PROBLEM ADVISORY

1. TITLE MICROCIRCUIT, DIGITAL, CMOS, RADIATION HARDENED, 32-BIT FAULT-TOLERANT V8/LEON 3FT PROCESSOR, MONOLITHIC SILICON			2. DOCUMENT NUMBER SPO-2013-PA-0002

UT699 PCI Reset and Clock Requirements

Figure 1. Timing Relationships of Clock and Reset Inputs for PCI Core Utilization

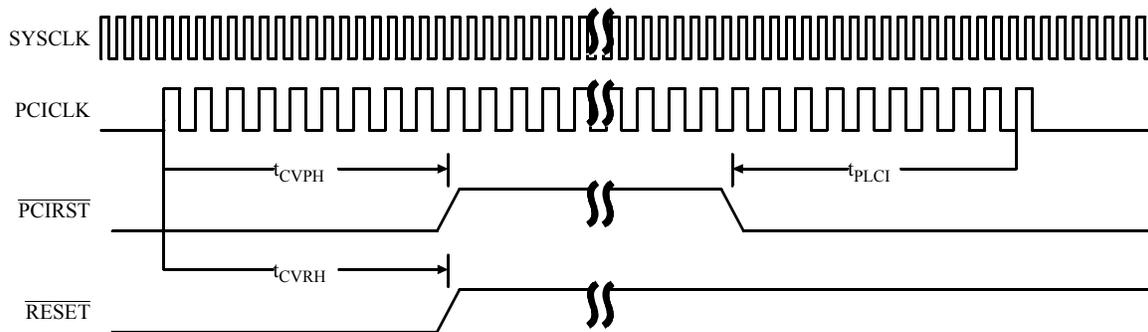
Figure 1 shows the required timing relationship between the PCI clock input and the $\overline{\text{RESET}}$ and $\overline{\text{PCIRST}}$ inputs when the PCI core is utilized. It is assumed that the V_{DD} and V_{DDC} power rails are stable and the SYSCLK input has a valid clock as described in **Section 4.1 Power Sequencing and Reset** of the *UT699 Leon 3FT Data Sheet*. Parameters t_{CVPH} and t_{CVRH} are specified in PCI clock cycles and must be met in order to ensure that the PCI state machine is initialized to idle state prior to the execution of code. $\overline{\text{RESET}}$ may be deasserted after 10 valid PCI clock cycles. There is no timing requirement for $\overline{\text{RESET}}$ relative to $\overline{\text{PCIRST}}$. The PCI core may be held in reset by asserting $\overline{\text{PCIRST}}$ until core utilization is required.

If clock gating is used to reduce power, the PCI clock can be disabled after delaying t_{PLCI} following the assertion of the $\overline{\text{PCIRST}}$. Refer to Table 2 for a summary of the timing parameters.

Figure 2. Timing Relationships of Clock and Reset Inputs for Unused PCI Core

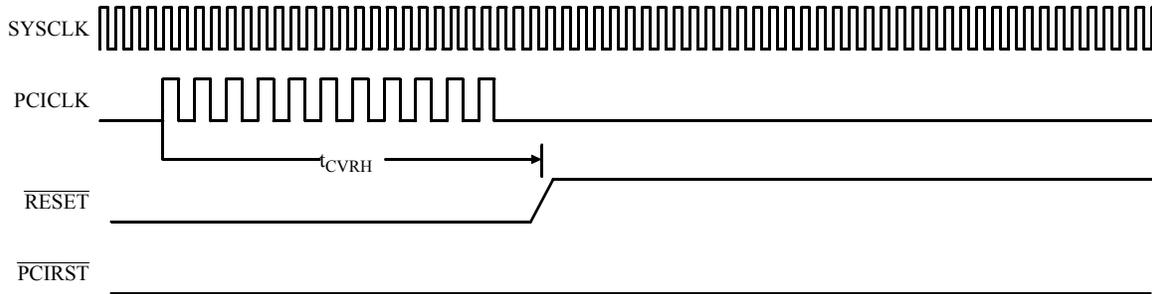
Figure 2 shows the required timing relationship between the PCI clock input and $\overline{\text{RESET}}$ when the PCI core is not utilized. It is assumed that the V_{DD} and V_{DDC} power rails are stable, and that the SYSCLK input has a valid system clock per **Section 4.1 Power Sequencing and Reset** of the *UT699 Leon 3FT Data Sheet*. The critical timing parameter is t_{CVRH} which must be met in order to ensure that the PCI state machine is initialized to idle state. $\overline{\text{RESET}}$ may be deasserted after 10 valid PCI clock cycles. The PCI clock input may be permanently tied low or high immediately following the rising edge of $\overline{\text{RESET}}$. Since PCI is not being used, $\overline{\text{PCIRST}}$ is permanently tied to V_{SS} .

Refer to Table 2 for a summary of critical and recommended timing parameters.
